LAND DEVELOPMENT TEAM (LDT) APPLICATION RESPONSE LETTER, SUBMITTAL # 4

PROJECT ADDRESS: 505 East Los Olivos Street
PLN RECORD #: PLN2024-00299
DATE: Monday, May 12, 2025 – Review # 4
APPLICANT: Ben Eilenberg, THE MISSION LLC
socialindustrialequities@gmail.com
ASSIGNED PLANNER: Barbara Burkhart, BBurkhart@SantaBarbaraCA.gov
STATUS: INCOMPLETE

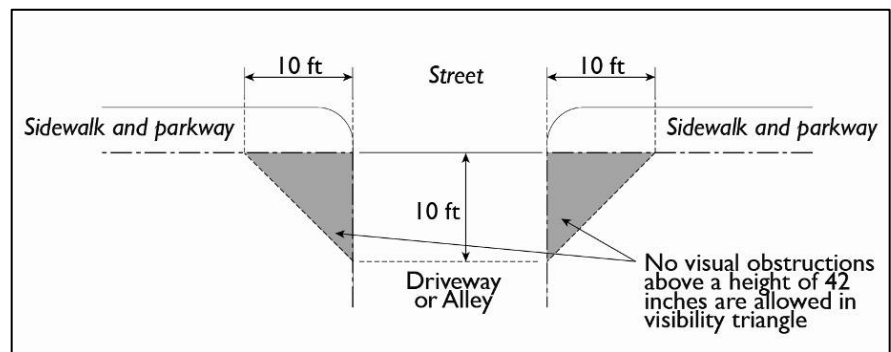
Show the Site Visibility Triangle per SBMC §30.140.230., Visibility at Driveways and Intersections for the proposed development, including public improvements. ~~Your response letter indicates that this information is provided on the Civil Sheets, however it is not provided on any sheet in the plan set.~~ See below for further clarification on how to depict this on the plans.

- **SBMC §30.140.230.B Driveways.** Visibility at a driveway that crosses a front property line shall not be blocked above a height of 42 inches within the triangle areas described below:

- **Street with Sidewalk and Parkway.** When a driveway directly abuts a portion of a street with a sidewalk and parkway, the triangle is measured on two sides by a distance of 10 feet from the side of a driveway and 10 feet back from the front lot line.

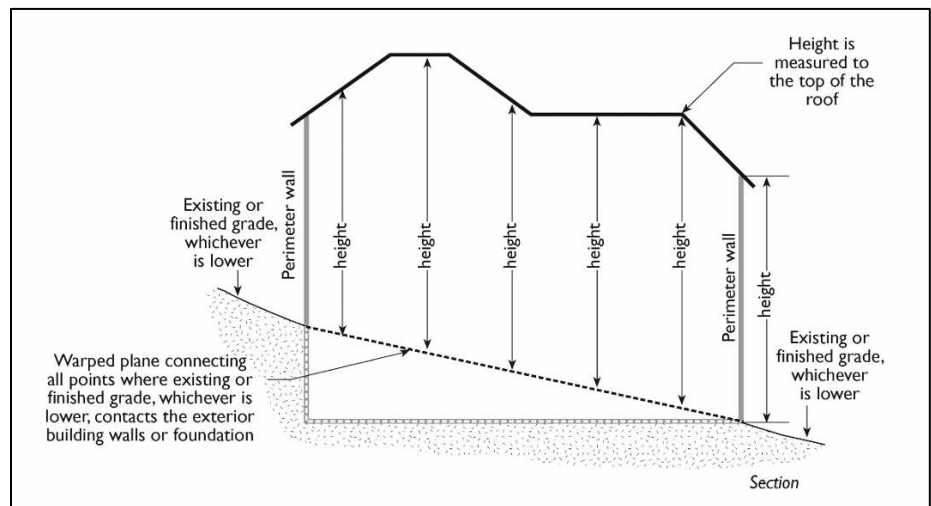
- **Building Height** (the following comments were moved from Section III, Additional Information Required)

the exterior building walls or foundation system. See SBMC §30.15.090.A for additional information. Building heights are not dimensioned on Sheet A.2.02. Building heights on Sheet A.2.03 are not dimensioned for the elevation labeled, “Wing 2 – South Elevation,” and are shown incorrectly on the right side of the elevation labeled, “Wing 2 – West Elevation.” Please revise. Although building height was identified on the elevations, it was not shown correctly.

See below for further clarification on how to depict this on the plans.

- SBMC §30.15.090.A. Measuring Building Height. Building height is measured from every point on top of the building roof or roof parapet to a warped plane directly below connecting all points where existing or finished grade, whichever is lower, contacts the exterior building walls or foundation system.

Figure 1. Floodplain and Floodway Outlines

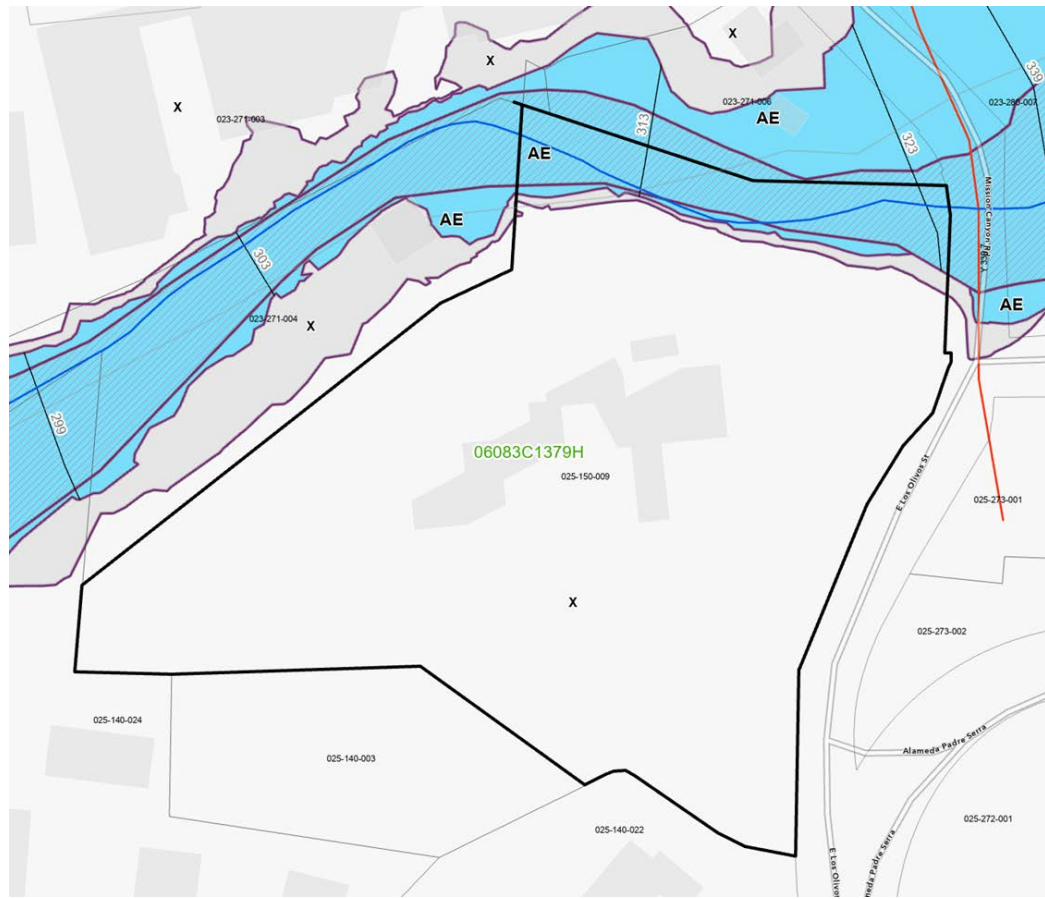
Provide a site civil engineering drawing locating the Regulatory Floodway and Floodway Fringe boundaries.

- b. Accurately show the AE floodplain and the AE floodway (hatched), as identified in Figure 2 below, on Sheet A.0.01. Identify all proposed structures, buildings, flat work, and site walls on this plan.
